Meeting Agenda

Historic Zoning Commission

Monday, September 11, 2023

115 W. Franklin St. • Suite 103
Gallatin • Tennessee • 37066
(615) 265-7796

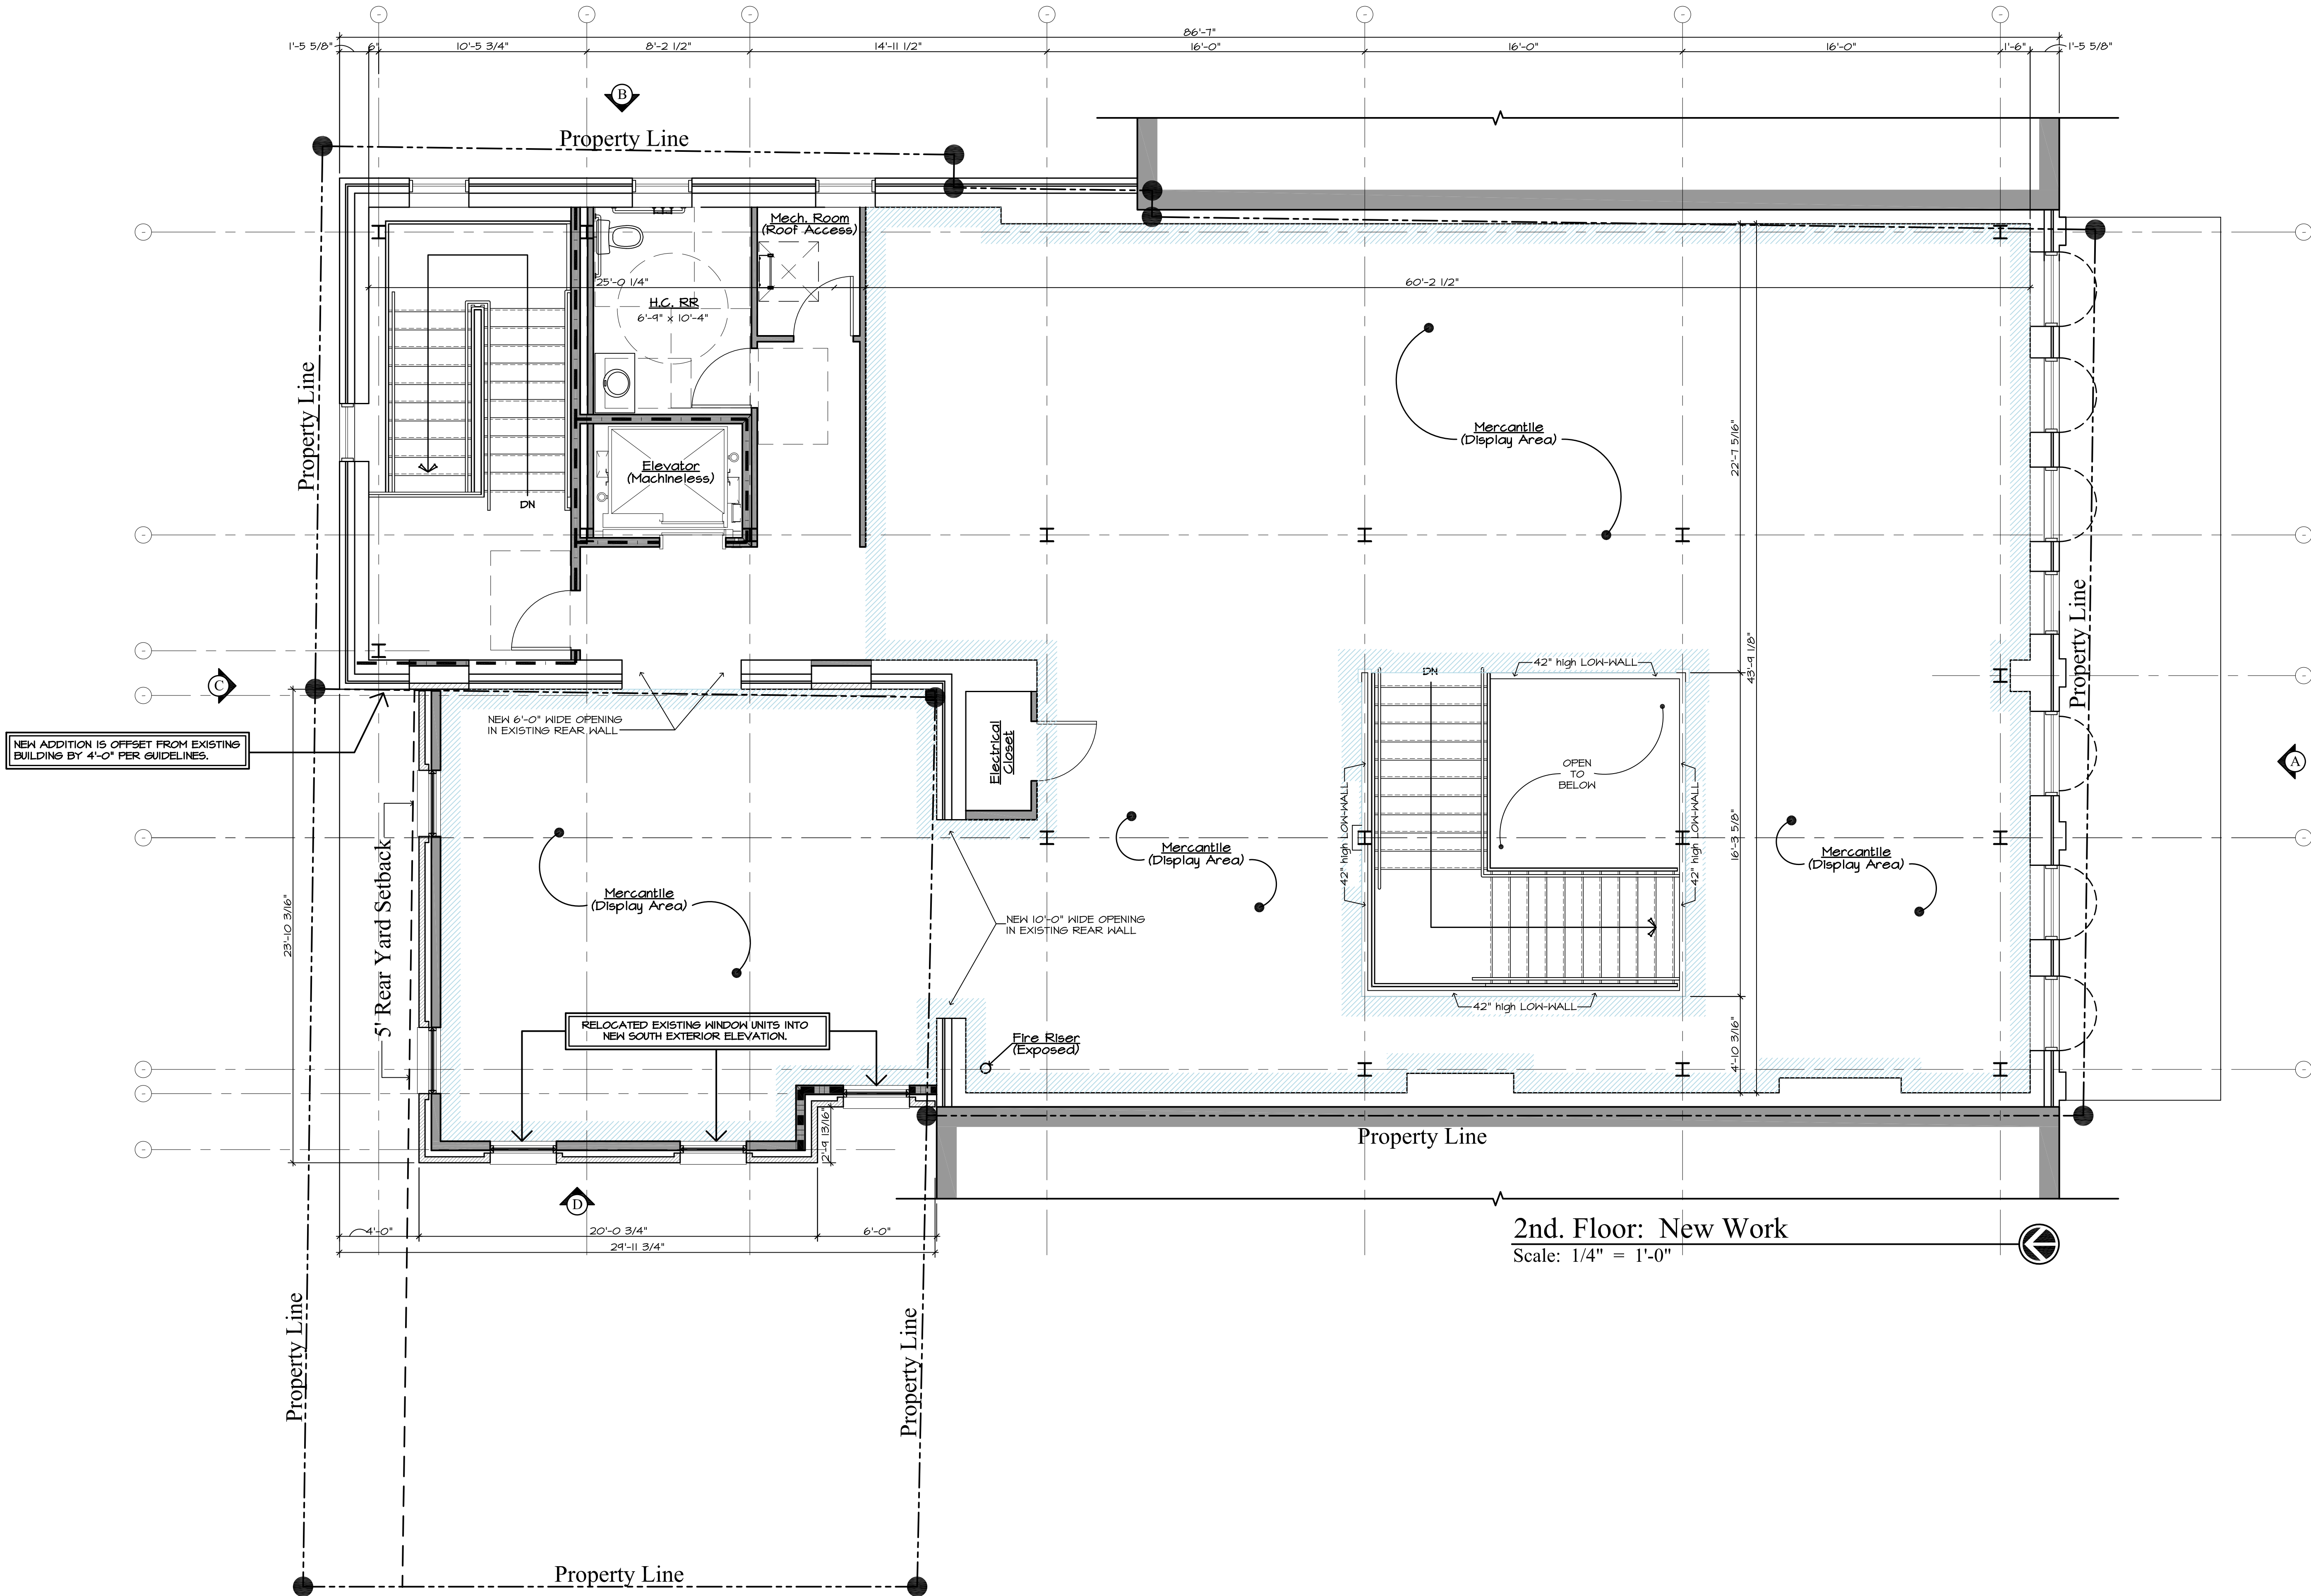
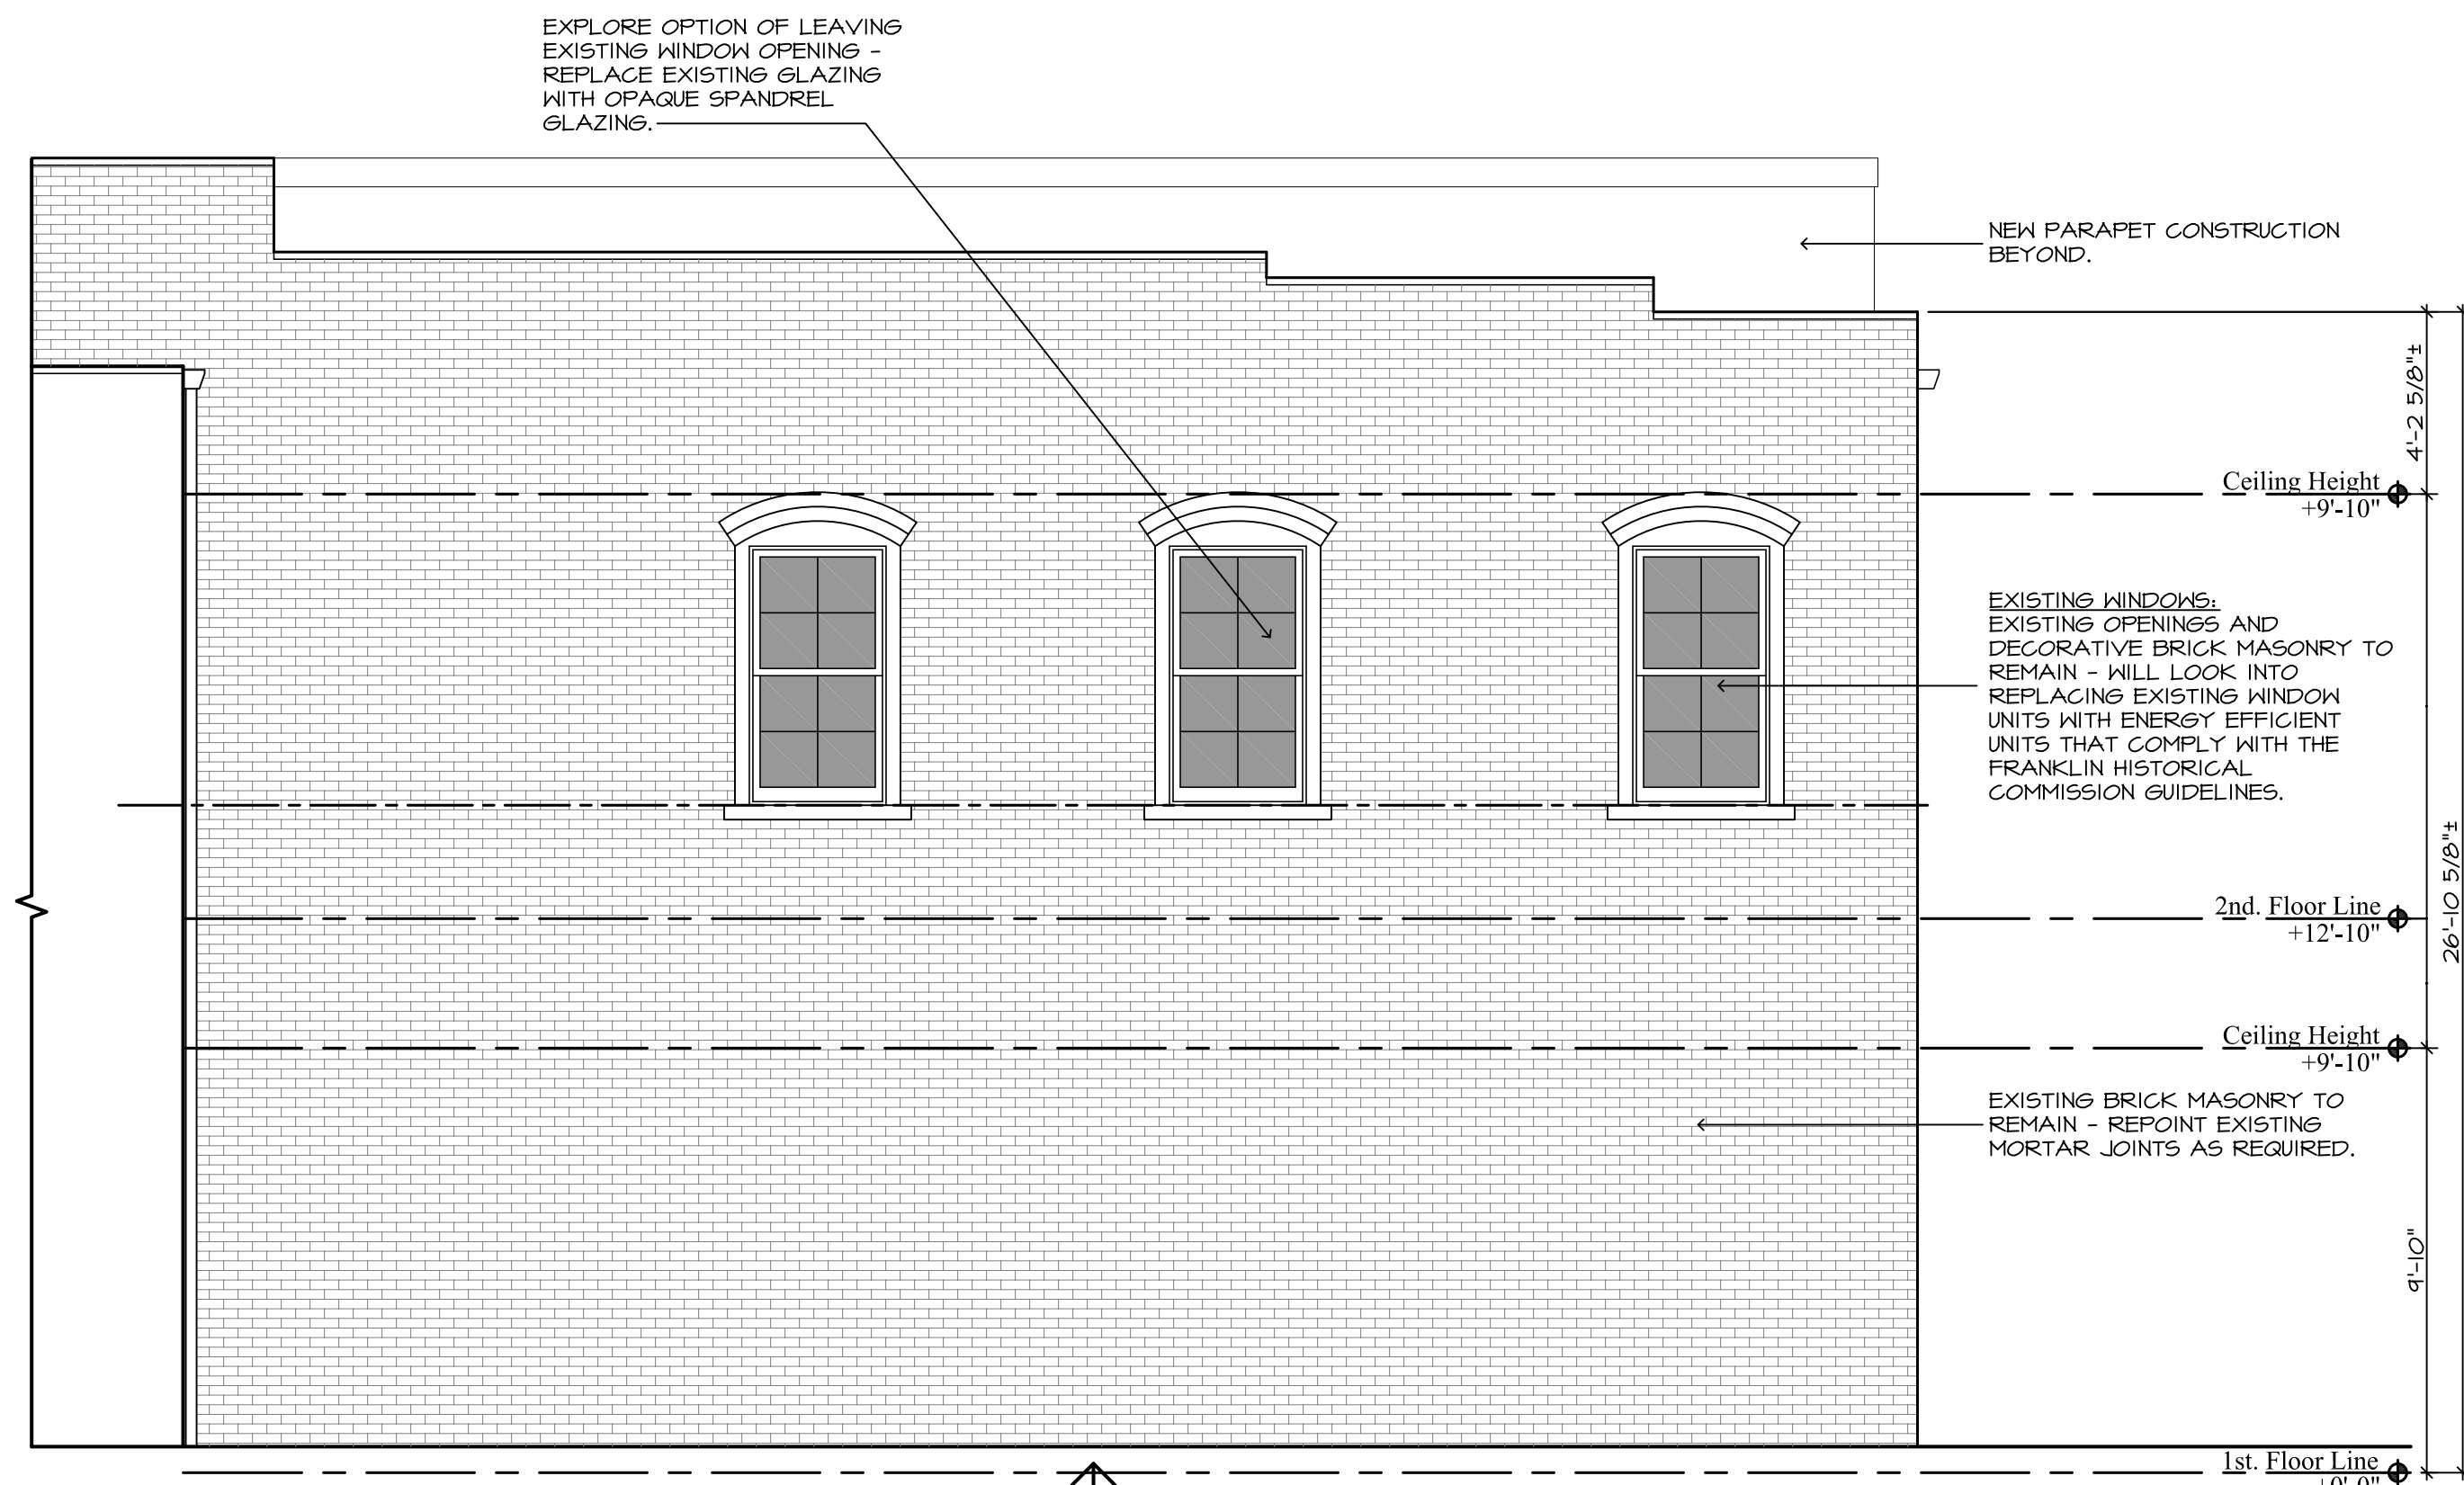
- Design additions to be subordinate in appearance to the historic building. Considerations include placement, size, massing, scale, height, setbacks, and materials.
- Avoid removal of sections of historic walls to accommodate additions unless significant structural deficiencies can be demonstrated. Design additions so that owners may remove the additions and restore the original facade if so desired.

Staff recommends denial of this application based on the following grounds:

1. Design additions to be subordinate in appearance to the historic building.
2. Avoid removal of sections of historic walls to accommodate additions unless significant structural deficiencies can be demonstrated.

1. The lots owned by the property owner must be consolidated prior to construction to be in compliance with the rear lot setback requirements.
2. The proposed brick and mortar shall match the historic brick, with a material sample of the brick and mortar subject to approval by the Preservation Planner or the Historic Zoning Commission.
3. The proposal for front door replacement shall be submitted as a separate COA application.
4. The application must meet all the requirements of the City of Franklin prior to issuance of a building permit.
5. Any additional changes to the approved plans must be returned to the Preservation Planner or the Historic Zoning Commission for review and approval.
